Orano TLI hereby submits the response to the Request for Additional Information (RAI), issued on May 3, 2021, for Revision 13 to the Versa-Pac Safety Analysis Report (SAR), Docket No. 71-9342. The response to the RAI is documented in Attachment 1 to this letter and Revision 13 of the Versa-Pac SAR with change pages resulting from the RAI Response are also enclosed in this submittal. Change pages in the SAR are marked 'June 2022' in the header and a summary of all changes is provided in Attachment 2 to this letter. The affidavit for withholding from public disclosure is documented in LTR-20000-130-04, submitted jointly with this application along with a redacted version of the updated SAR.

Attachment 1 – RAI Responses

Figure 2-1.1. Model Coordinate System

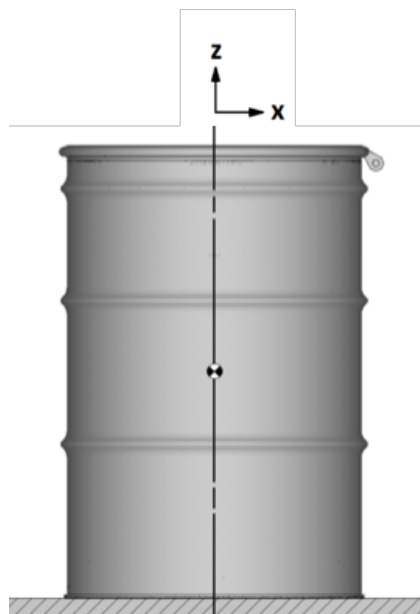
Demonstrate how the dynamic structural responses of the Versa-Pac 55 (VP-55) transportation package for the center-of-gravity (C.G.) over the bottom corner drop orientation are bounded by the dynamic structural responses of the bottom-end and side drop orientations.

In SAR Section 2.12.2.2 “Method of Analysis,” of the SAR, the applicant stated that four package orientations were considered for the evaluations of the VP-55 package under the normal conditions of transport and hypothetical accident conditions free drops: (i) bottom-end, (ii) top-end, (iii) side, and (iv) C.G. over top-corner. However, the applicant provided a statement in the section without providing any explanations, “A drop with the c.g. over the bottom corner is bounded by the bottom-end and side drop orientations and is therefore not evaluated.” Provide explanations of how the responses of the C.G. over the bottom corner drop are bounded by the responses of the bottom-end and side drops.

The C.G. over bottom corner cases are added to the SAR. Figure 2-1.1 shows the model coordinate system with the NCT and HAC results presented in Table 2-1.1 and Table 2-1.2, respectively. Review of the results shows that the component accelerations are bounded by the bottom-end and side drop cases. Additionally, because of the lid geometry, the top-end C.G. over corner drop bounds the bottom-end C.G. over corner results. Further discussion is provided in the response to RAI 2-2.

Figure 2-2.1. HAC Top-Corner Impact Simulation—Comparison of Hot/Soft and Cold/Hard Foam Properties

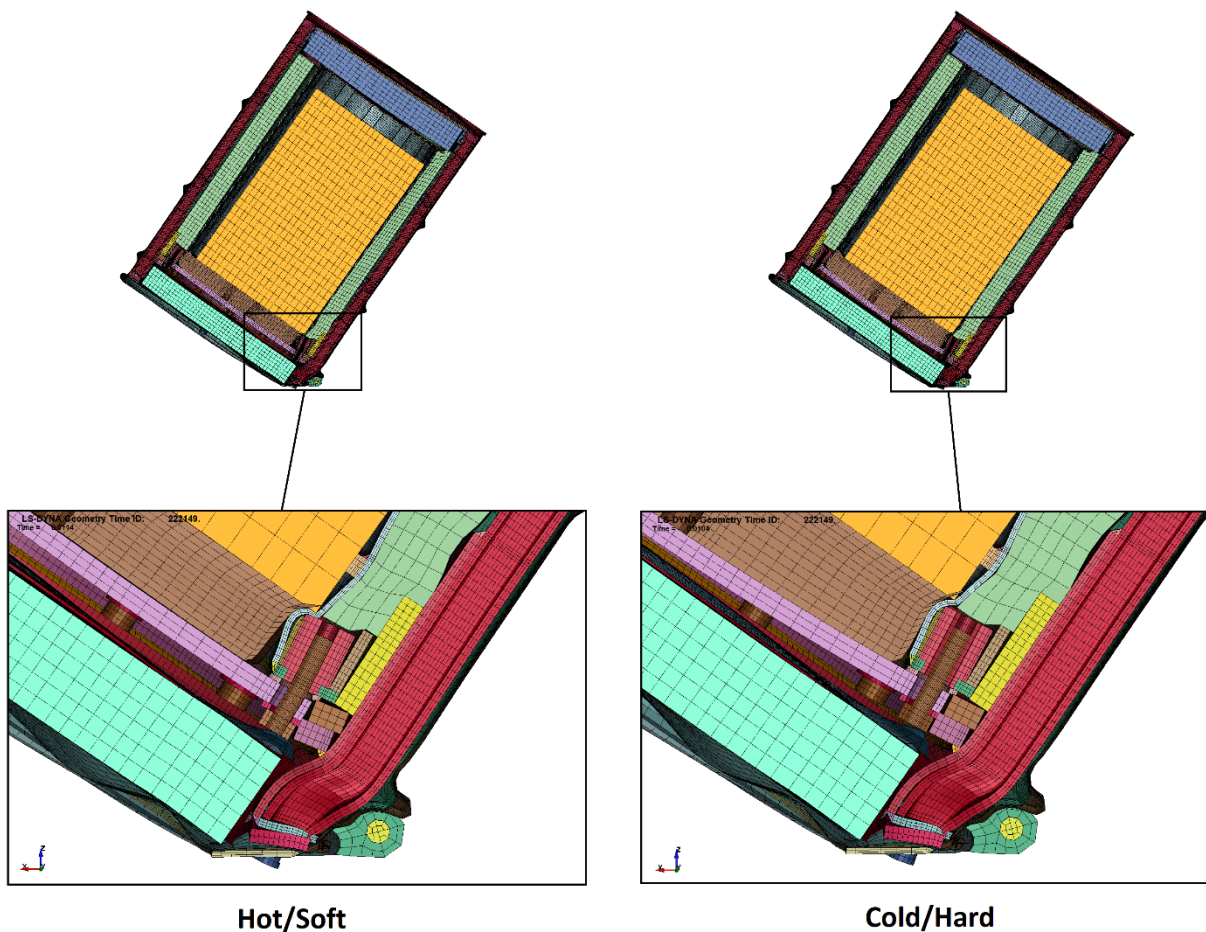
- a) The applicant provided the calculated peak accelerations of the package in SAR Tables 2-8 and 2-9 from the results of the LS-DYNA finite element (FE) analyses. a) SAR Table 2-8 shows that all peak accelerations of the Cold/Hard Form are larger than the peak accelerations of the Hot/Soft Foam for each orientation. However, SAR Table 2-9 shows that the peak accelerations of the Cold/Hard Form are smaller than the peak accelerations of the Hot/Soft Foam for the Top-End and C.G. over Top-Corner orientations.

- b) For the use of Cold/Hard Form, the largest acceleration (133 g) was obtained with the C.G. over Top-Corner orientation in SAR Table 2-8, while the largest acceleration (515 g) was obtained with the side orientation in SAR Table 2-9. However, when the Hot/Soft Foam was used, the largest acceleration (105 g) was obtained with the side orientation in SAR Table 2-8, while the largest acceleration (422 g) was obtained with the C.G. over Top-Corner orientation in SAR Table 2-9. Provide: (a) explanations of the effects of the orientation and material properties with respect to the VP-55 performance under normal conditions of transport and hypothetical accident conditions free drops, and (b) technical justifications that the LS-DYNA analyses are accurate and consistent.

While the use of the cold/hard foam properties produces higher accelerations than do the hot/soft foam properties for the NCT top-corner impact as would be expected, this is not the case for the HAC top-corner impact as originally presented. This unexpected phenomenon is caused by how the different foam properties allow the mock contents to interact with the closure mechanism of the VP-55 Inner Container.

During the HAC top-corner impact simulation with hot/soft foam properties, the ceramic blanket surrounding the Inner Container (modeled as foam) and the Containment Insulation Plug does not provide as much support to the Inner Container Containment Body as the foam with cold/hard foam properties. This allows the corner of the simulated contents to deform the Containment Body to such an extent that it pinches the Containment Body between it and the Inner Container threaded insert, which is part of the Inner Container closure mechanism. This metal-to-metal interaction results in higher accelerations to the simulated contents.

During the HAC top-corner impact simulation with cold/hard foam properties, the ceramic blanket surrounding the Inner Container (modeled as foam) provides enough support to the Inner Container Containment Body to allow the simulated contents to slide along the Containment Body—directing it to the Containment Insulation Plug, which provides additional cushioning to the contents. This keeps the Containment Body from being pinched between the simulated contents and the Inner Container threaded insert—resulting in lower accelerations to the simulated contents.

Figure 2-2.1 presents the deformation of the package near the Inner Container closure mechanism at times during the analyses when the simulated contents had reached its lowest point before rebounding. As can be seen in this figure, there is more deformation of the Inner Container Body with it being pinched between the simulated contents and Inner Container threaded insert.

Figure 2-3.1. HCB ANSYS Model Contact Details

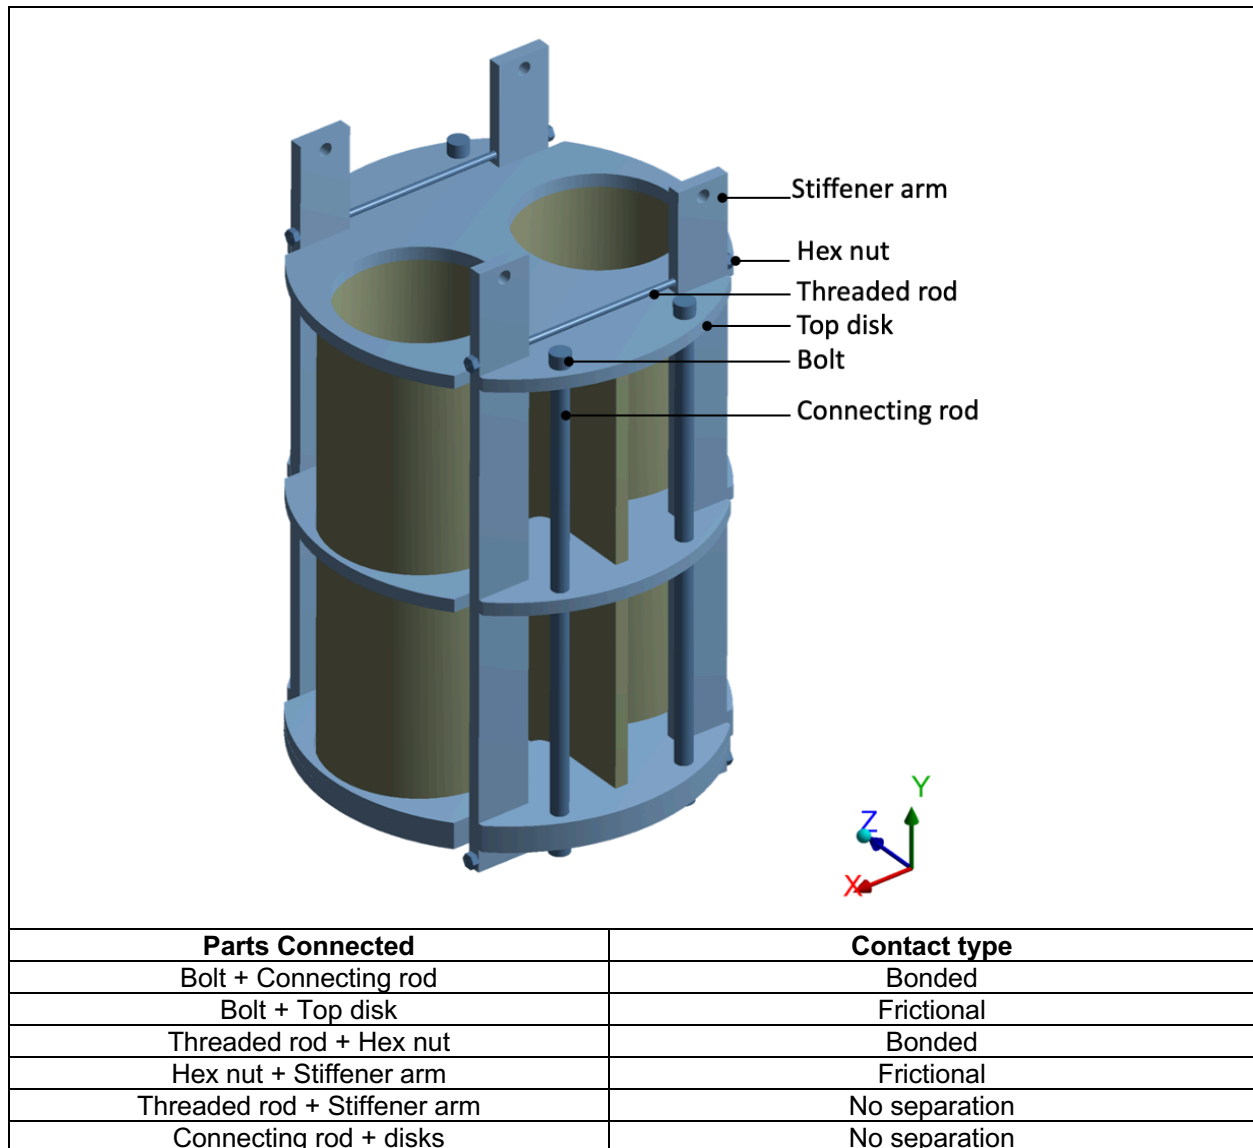
- a) Explain the statement of "with bounded contact," in SAR Section 2.12.3.3,
- b) Provide details of how the bolt and its connection were modeled,
- c) ANSYS contact elements were used for interactions between components. Explain how friction was treated for the contact elements and what criteria were used to determine a status of fixed, friction and free condition during an impact,
- d) If a fixed condition was used between components, provide technical justifications whether or not the ANSYS analyses provide conservative responses, and
- e) Provide a benchmark study that demonstrates the validity of the ANSYS numerical analyses to accurately predict responses of the HCB by physical model test.

As shown in Figure 2-3.1, Bonded contact is used between the bolts and connecting rods, and threaded rods and hex nuts. Frictional contact is used between bolts and disks, hex nuts, and stiffener arms. No separation contact is used between the threaded rods and stiffener arms and connecting rods and disks.
